TOWN OF ARLINGTON
Public Works Standard Details

RESIDENTIAL DRIVEWAY
TYPICAL SECTION

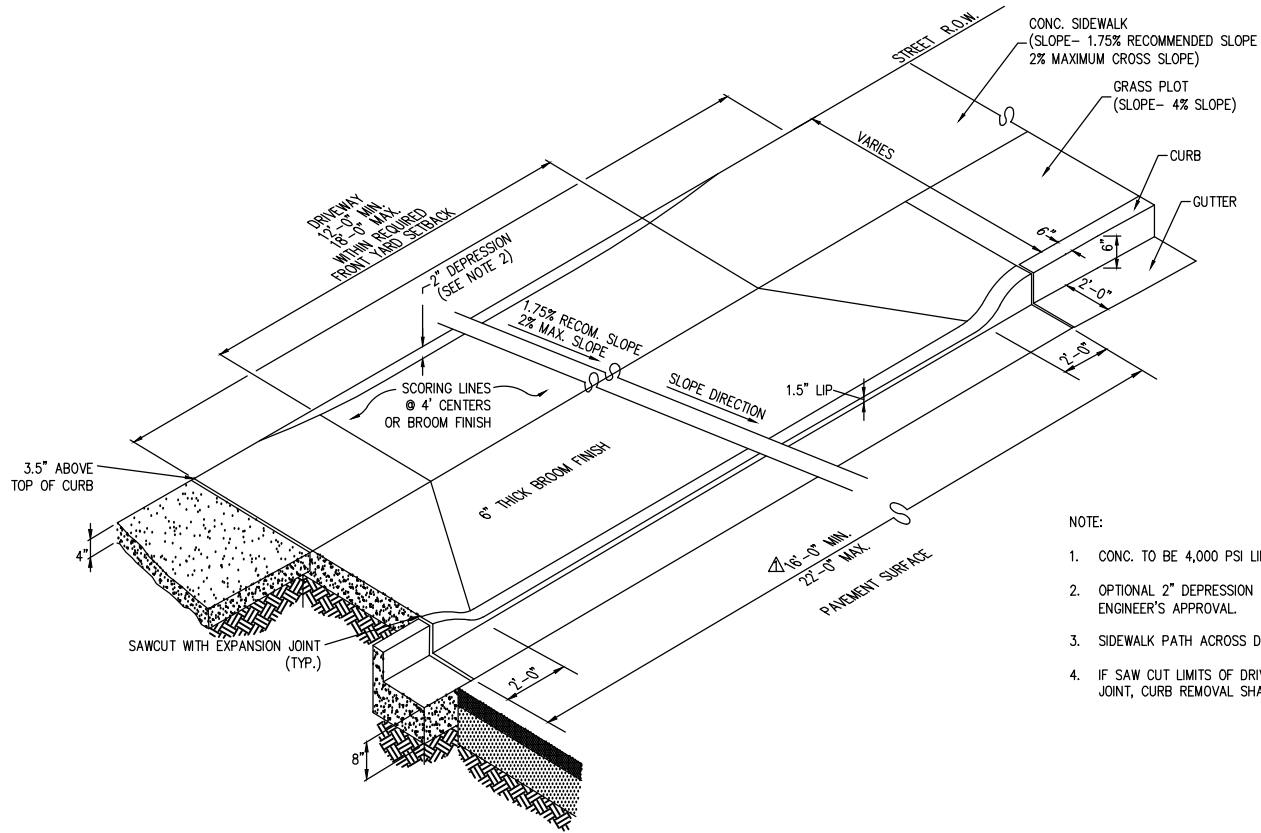
REV. 1: REDUCED MINIMUM DRIVEWAY OPENING
AT STREET FROM 20' MIN. TO 16' MIN.
